**DEVIATION REQUEST
 AND DECISION FORM**

Project Name : Crossroads at Meadowbrook Mixed Use Preliminary Plan
 Schedule No.(s) : 5408007005
 Legal Description : A portion of Tract B 24/94 Business Park Fil No. 1, as amended by affidavit of correction rec. #219097386

A deviation from the standards of or in Appendix F, Standard Drawings, **SD 4-4, Urban Residential Collector-** of the Engineering Criteria Manual (ECM) is requested.

Figure 2-15. Typical Urban Residential Collector Cross Section Traffic volumes up to 10,000/day

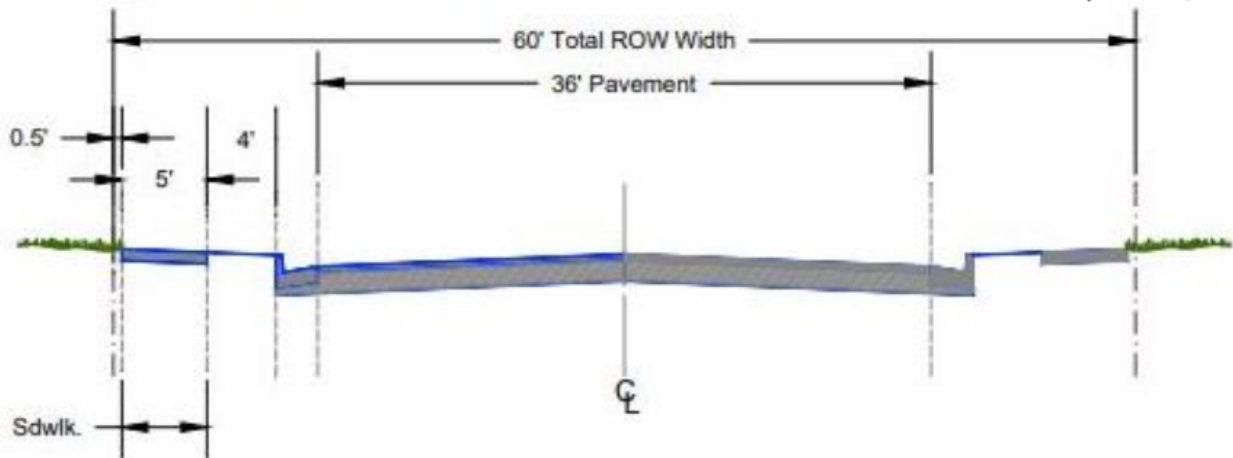
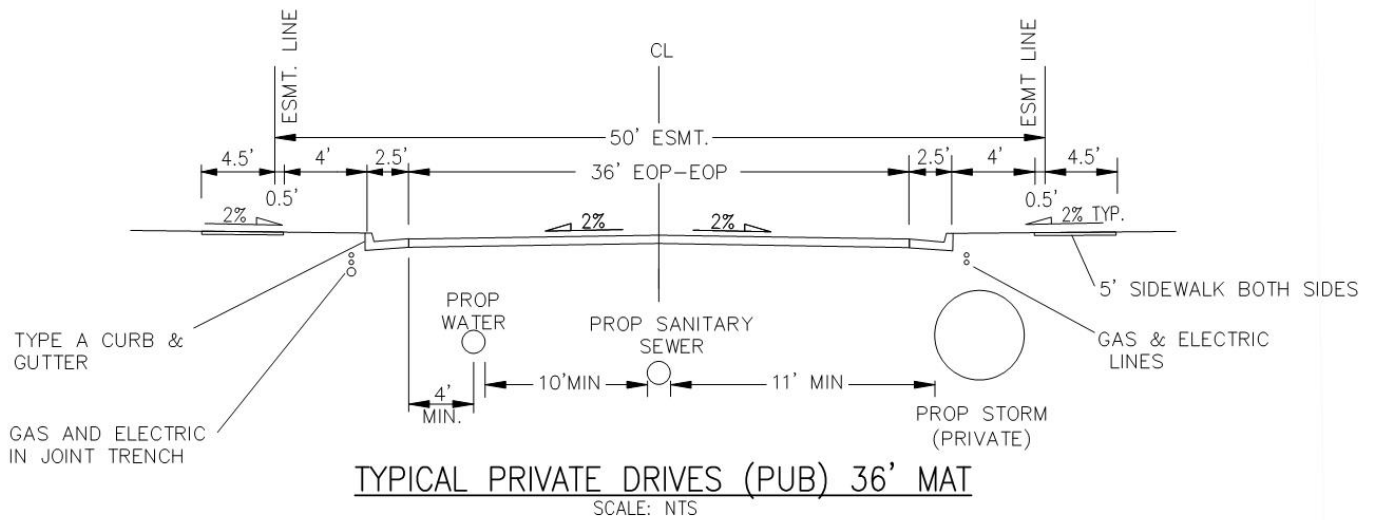
A deviation from the standard Urban Residential Collector Roadway Cross Section is requested. The standard cross section includes two travel lanes within a 36-foot wide pavement mat; two 2.5-foot curb and gutter at the end of the pavement mat; two (2) four (4) foot (typical) landscape/tree lawns; two (2) five (5) foot detached sidewalks all within a 60-foot ROW.

The applicant requests a deviation from the 60-foot ROW width, along with a 4.5' landscape lawn for a private road to be known as Pacific Rail Point.

The proposed private road cross section includes the following deviation from standard ECM Standards for an urban residential collector section.

- 50-foot tract dedicated for private road and utility use. Typical cross section is within a 60-foot Public ROW.
- 36 foot pavement width, where typical cross section has a 36' pavement width. No Change.
- Two 18-foot travel lanes, where typical cross section has two 18-foot travel lanes. No Change
- 5-foot detached sidewalk, where typical cross section has 5' detached sidewalks, No Change. However, the sidewalk is outside of the 50-foot tract. Attached sidewalk is not requested because it may cause problems with future development driveway cuts and ADA ramps.
